PROJECT: Senior Citizen Center Construction

CHANGE ORDER NO. 18

Proposal for Remediation of Subgrade Conditions
at Paved Areas for Vehicle Traffic and Parking

PROJECT NAME:	LFUCG Senior Citizens' Center
PROJECT NUMBER:	201333
SUBJECT:	Parking Subgrade Remediation - Revised
DUE DATE:	6/25/2015
ID:	PR-018
SENDER ID:	
INITIATED BY:	Harding Dowell
REASONS:	Field Conditions
DISCIPLINE:	Civil Site
STATUS:	Closed
COP STATUS:	Not Received
CONTRACT:	Construction Services for Replacement Senior Citizens Center

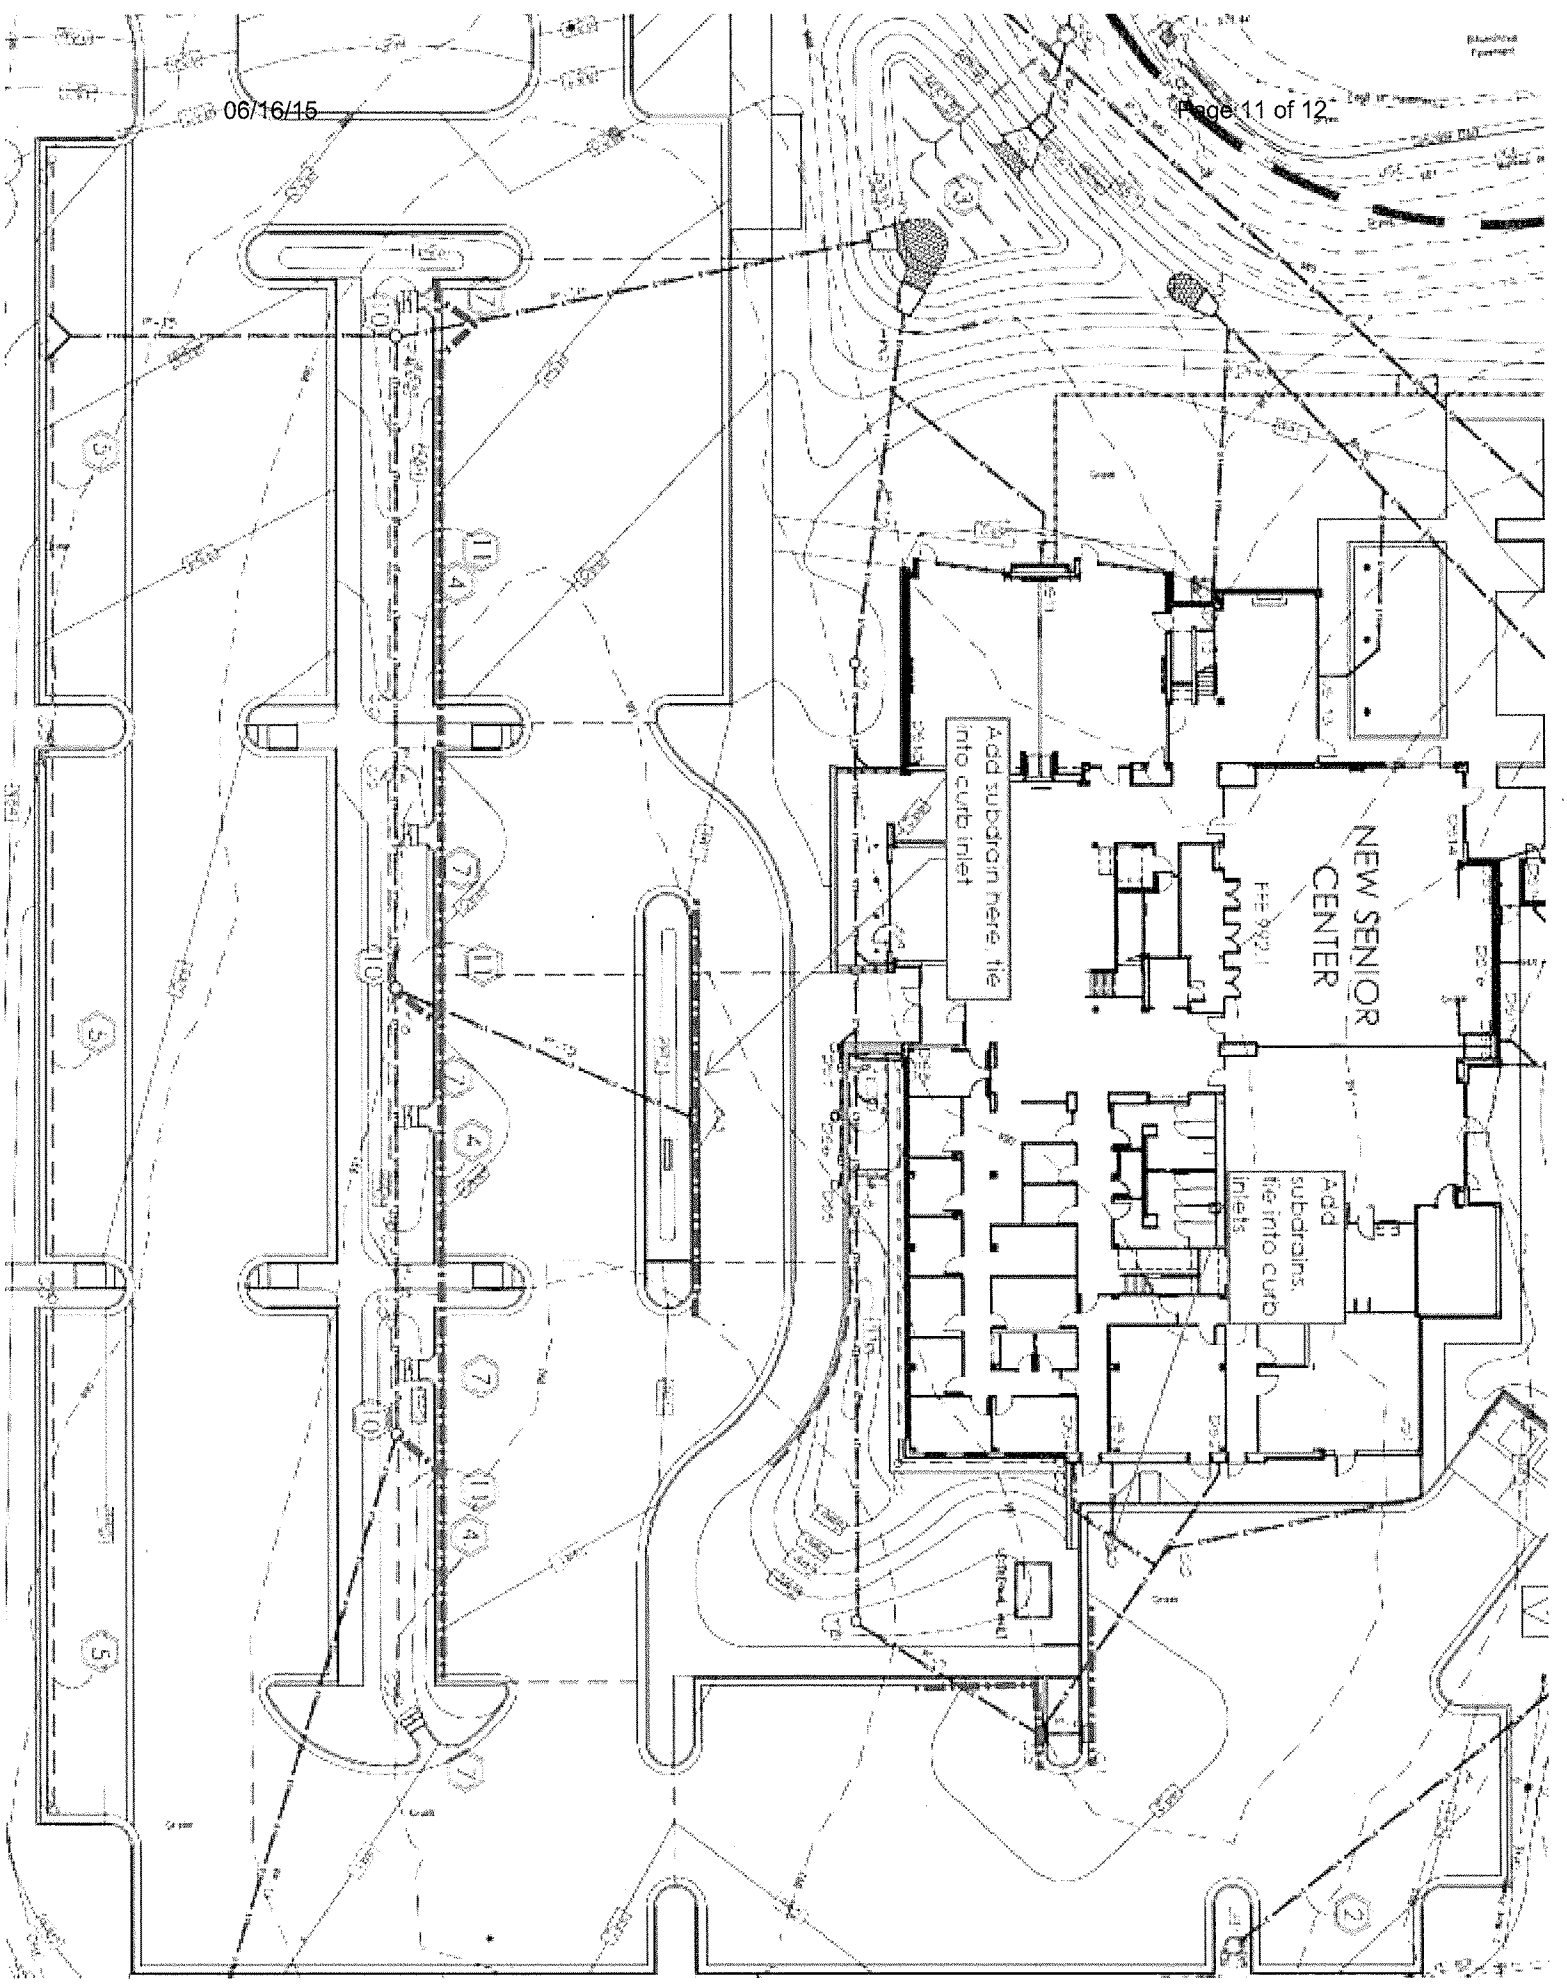
As a revision to Cardno's recommendation Option 1, one layer of woven high performance geosynthetic fabric replaces the lowest layers of filter fabric and geogrid noted in the attached document. This revision is illustrated in the attached profile section by Element Design and shall be included in the pricing.

Additionally, 6-inch diameter subdrains shall be included as noted in the plan drawing by Element Design. Subdrains shall tie into adjacent storm water structures.

- Line exposed undercut subgrade with woven high performance geosynthetic fabric such as Mirafi HP570. Provide lap of at least 18 inches to adjacent sides and ends.
